Modification Notice

Project: Airplane Lake Culvert Replacement - Baker Lake
Water Licence 3BM-BAK1526

Airplane Lake Culvert Replacement Project

Figure 1: Hamlet of Baker Lake - Airplane Lake culvert design.

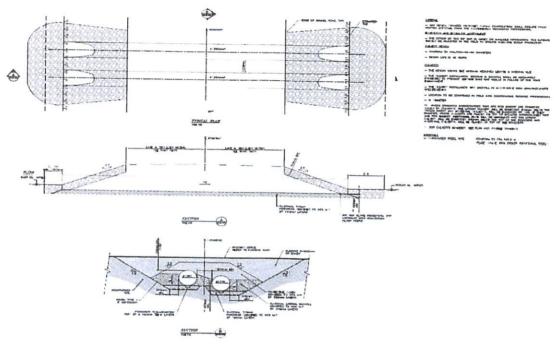
Two larger culverts are planned to be installed to replace a single culvert located prior to the inlet into Airplane Lake. Replacement of the Airplane Lake culvert is tentatively scheduled for October 2018. Airplane Lake is part of the sewage wetlands area and a sampling location is located prior the existing culvert (monitoring program station BAK-2). The inlet stream into Airplane Lake originates from Finger Lake, where the sewage facility effluent compliance point is located (monitoring program station BAK-5). The Airplane Lake culvert had been installed for drainage purposes with the roadway, prior to the 2011 sewage system improvement project. The culvert replacement project is intended for the improvement of the roadway and to prevent reoccurring road washouts. The "Airplane Lake Culvert Replacement Project" report is attached with more information and the engineering drawing of the culvert replacement. In accordance with Licence Condition Part E, Item 4, as-built drawings of the modification will be submitted to the NWB within ninety (90) days of completion of the modification.

Refer to Figure 1, which provides the replacement culvert design for Airplane Lake (complete design, including flow calculations is presented in Appendix B). The construction schedule is presented in Table 1.
